REMARKS

--LIQUID CRYSTAL DISPLAY DEVICE **WITH SUBSTANTIALLY BILATERALLY SYMMETRIC PIXEL ELECTRODES**--.

FIG. 3
Related Art

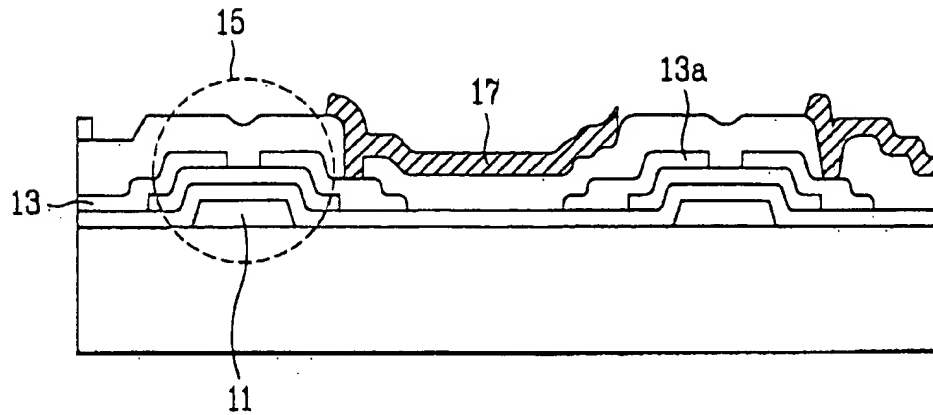
The drawings stand objected to because FIG. 3 should be designated by a legend such as "Prior Art."

The drawings stand objected to because Figure 3 should be designated by a legend such as --Prior Art-- because only that which is old is illustrated. The drawing has been amended, as indicated in the Request for Approval of Drawing Change filed concurrently herewith, by adding the legend "Related Art" to FIG 3. Applicants respectfully submit that the legend of "Related Art" is appropriate for designating that what is illustrated in FIG. 3 is old. In addition, the designation of FIG. 3 as "Related Art" is consistent with the "Related Art" designations of FIGs. 1 and 2. Accordingly, Applicants respectfully request that the objection to the drawings be withdrawn.

Applicants submit concurrently herewith a Request for Approval of Drawing Change to label FIG. 3 as "Related Art."

The drawings have been amended as indicated in the Request for Approval of Drawing Change filed with the current amendment.
